DES MOINES RECREATIONAL RIVER AND GREENBELT

FEATURE DESIGN MEMORANDUM #8 WITH ENVIRONMENTAL ASSESSMENT

DOWNTOWN RIVERFRONT PLAZA/AMPHITHEATER

NCD 3D ENDORSEMENT COMMENTS ON FDM NO. 8 DES MOINES RECREATIONAL RIVER AND GREENBELT PROJECT

Plat- 0-66

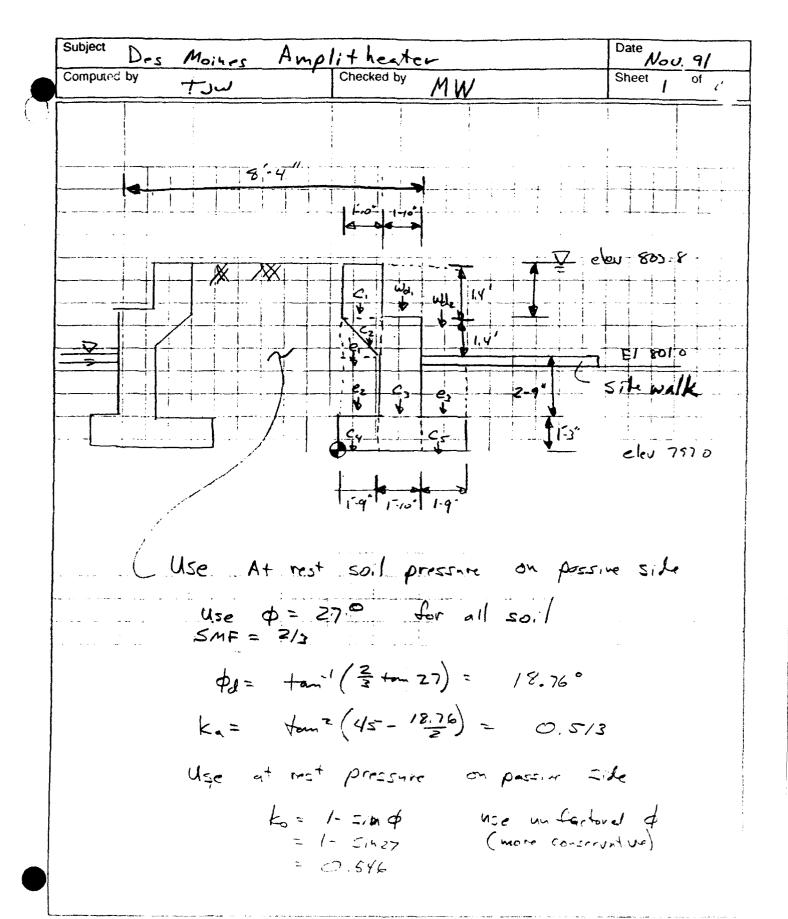
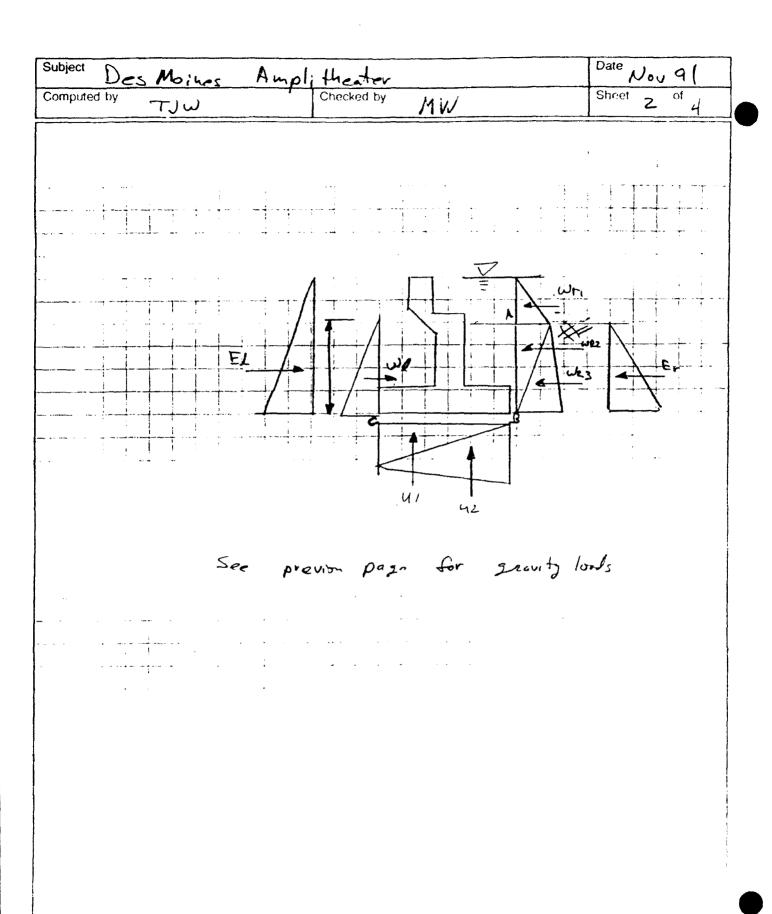
- 6. COMMENT: Retaining Wall Design, Plate D-65, assumed bottom of foundation E1.791 and top of stem at E1.803.8, while Drawing S-8, shows top of wall at E1.802.8 and bottom of foundation varying from E1.785 to E1.793. Verify that the assumed cross-section will be sufficient for the highest backfill level on the tallest wall. Analyze effect of wall foundation loads on existing sewer below.

- 14. COMMENT: Plate D-65, D-68 and D-103. The phi = 25 deg. is very conservative. A minimum of 30 deg. and possibly 32 deg. is recommended for footing design. Redo to see if a more economical retaining wall section results.

- 6. RESPONSE: The most conservative section was chosen for analysis. The section of wall closest to the river receives no surcharge from Locust Street or the sidewalk along locust street and does not have much of a difference between the

- 14. RESPONSE: Plates D-65 and D-68 Overturning is governing the design of the retaining wall and therefore increasing Phi from 25 to 30 deg. for the foundation material will not change the overturning stability of the wall. However, the analysis has been revised and the phi angle has been changed to 30 degrees.

3 2 1 57'-0" 12° DIA. 12" DIA. ARCH PLAN VIEW SCALE: # = r-0* Revisions Description Symbol U.S. ARMY E CORPS (ROCK ISL Designed by: DES MOINES RECREATION R DOWNTOWN R PLAZA/AMP Orom by: ARCH PLAN VIEN Checked by: Reviewed byt Seeler AS SHOWN Sheet reference numbers Deter Approved byl 5-5 2 3 1

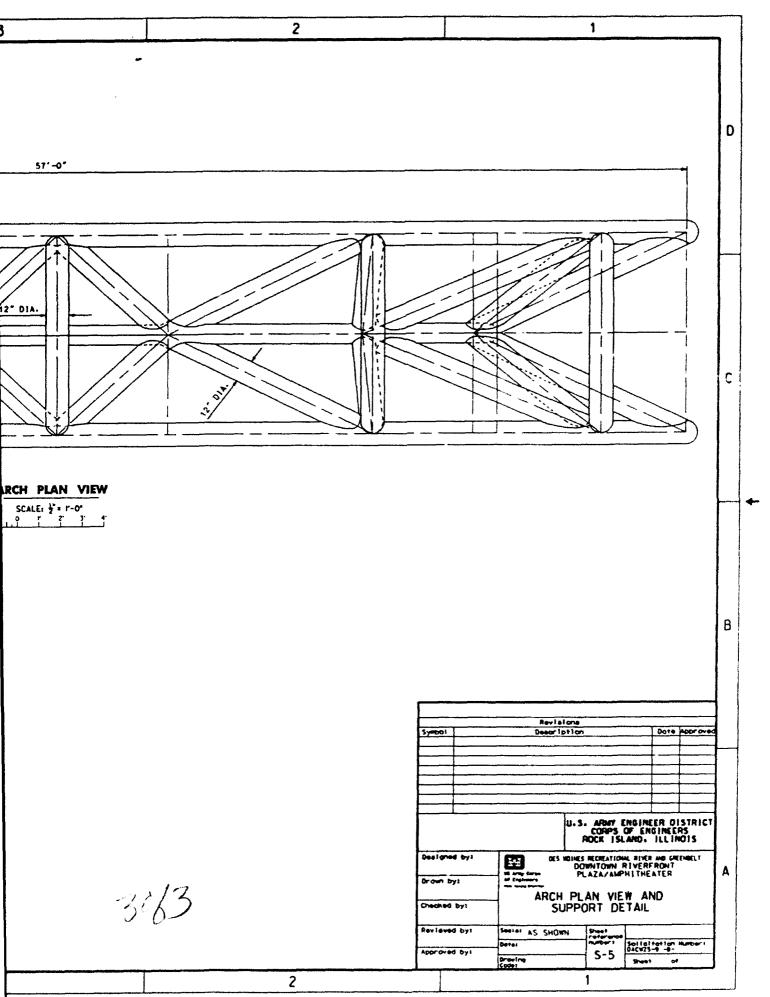
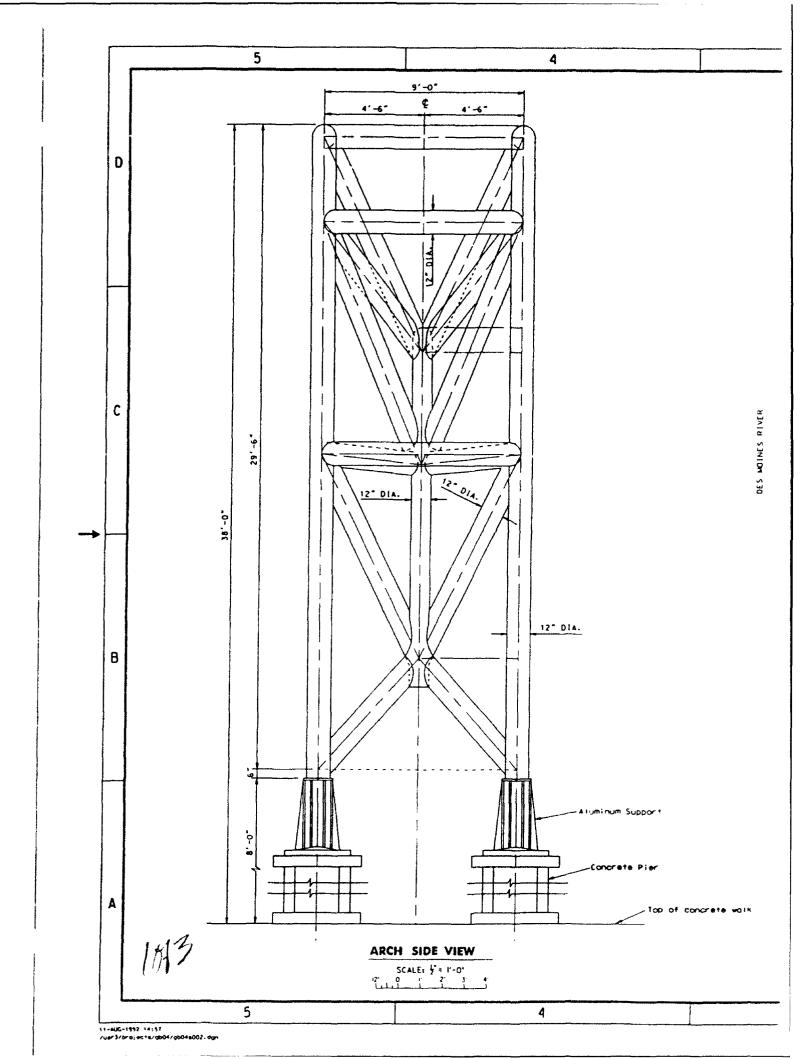
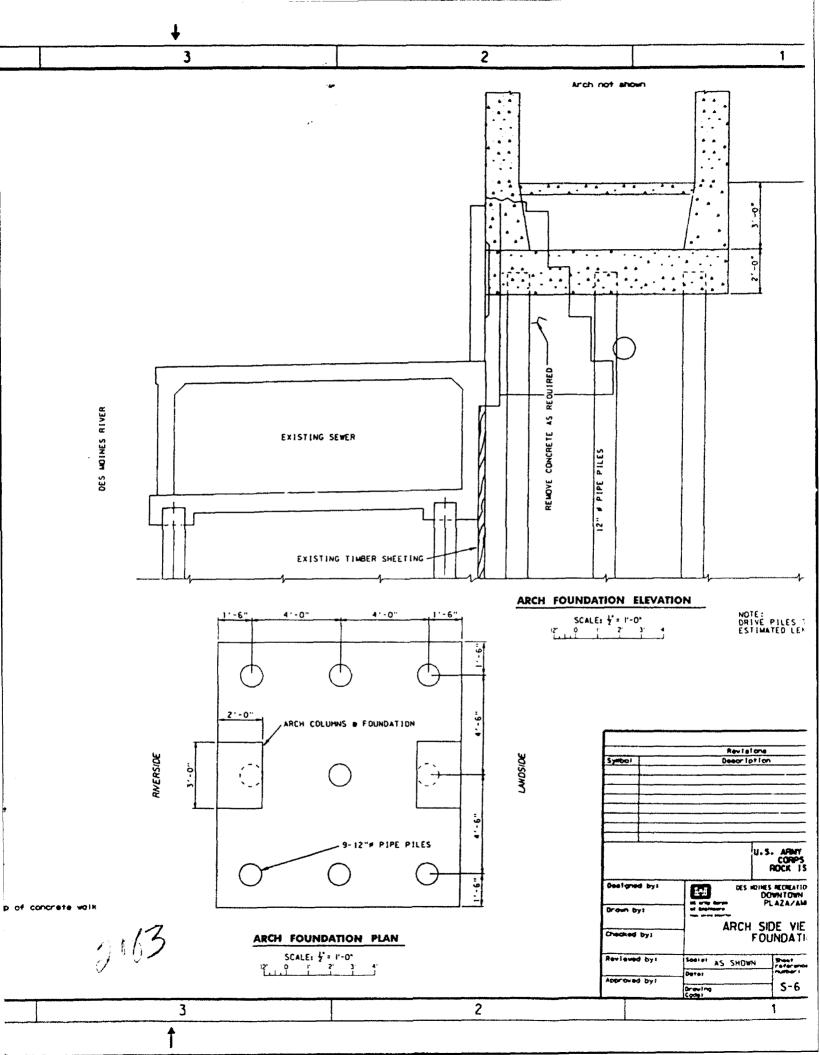
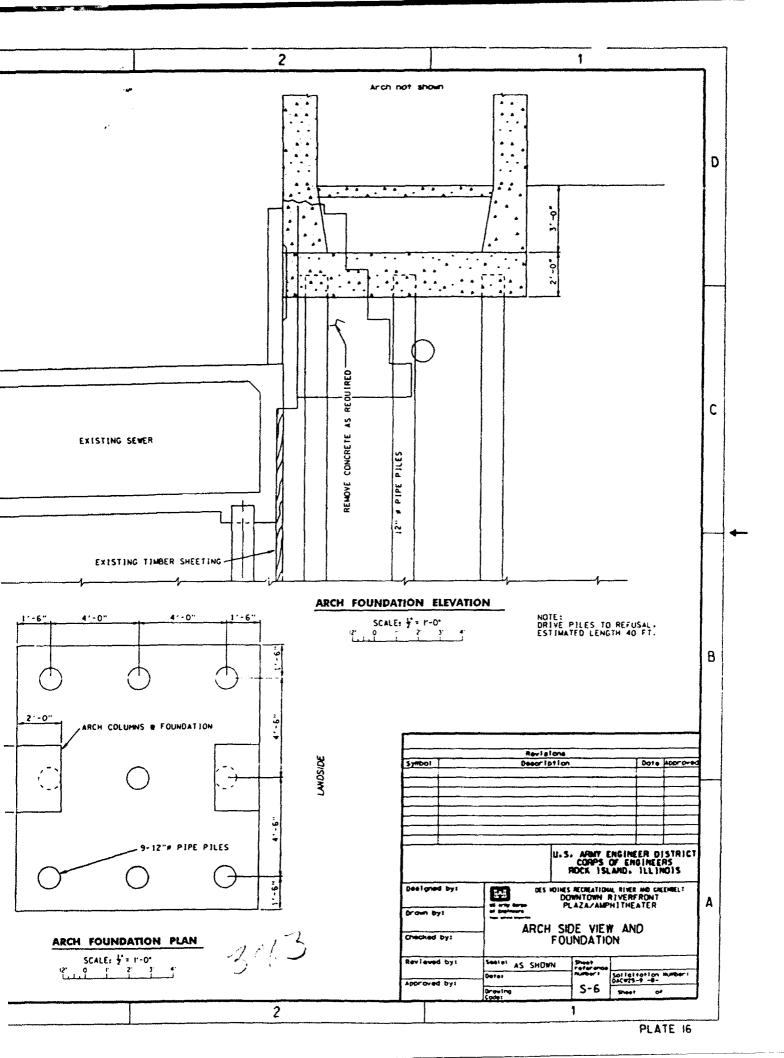
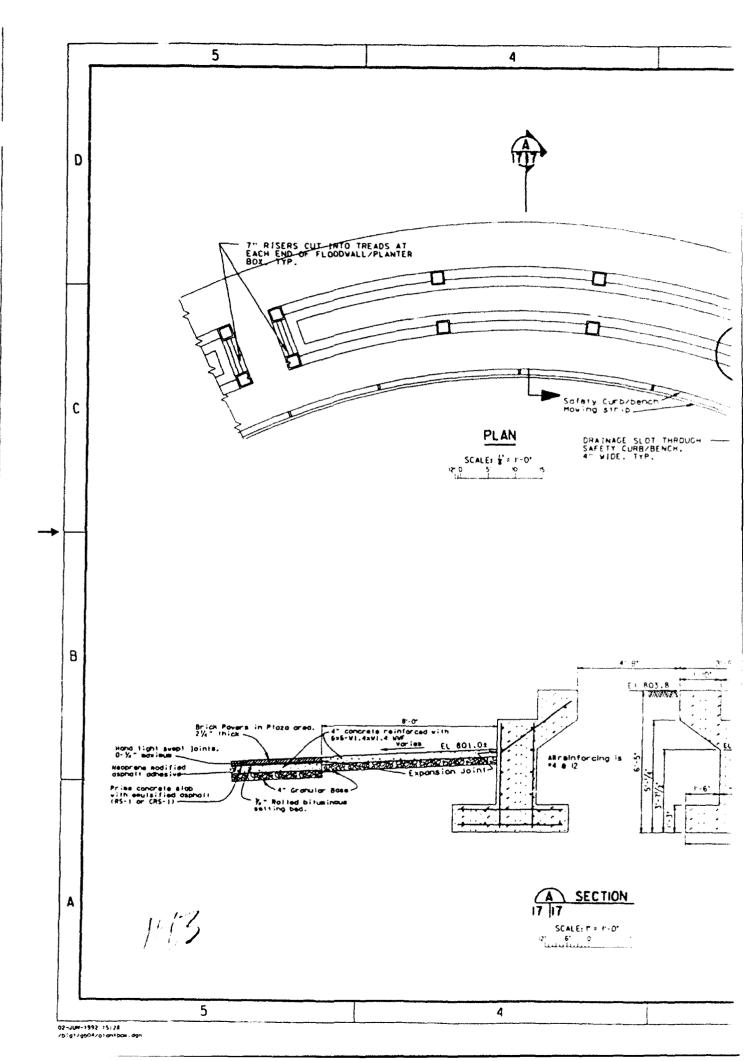
- 2. COMMENT: Appendix D. Structural calculations have not been checked. The input for the GT STRUDL lists dimensions to the outside of the 12" diameter pipe. Verify that the centerline need not be used. Sheet S-5, Arch Plan View, shows center to center dimension of 56'-11.25". It should be 57', because the outside dimension of the pipe is equal to 12". Explain the function of HP 14*73 indicated on the Support Detail.
- 2. RESPONSE: Appendix D has been completely revised. All structural calculations have been checked. The arch was modelled correctly; however, the center of the arch should be dimensioned rather than the outside as shown on the drawings. The HP14x73 has been deleted from the support detail. Plates 13, 14, and 15 were modified to reflect these changes.
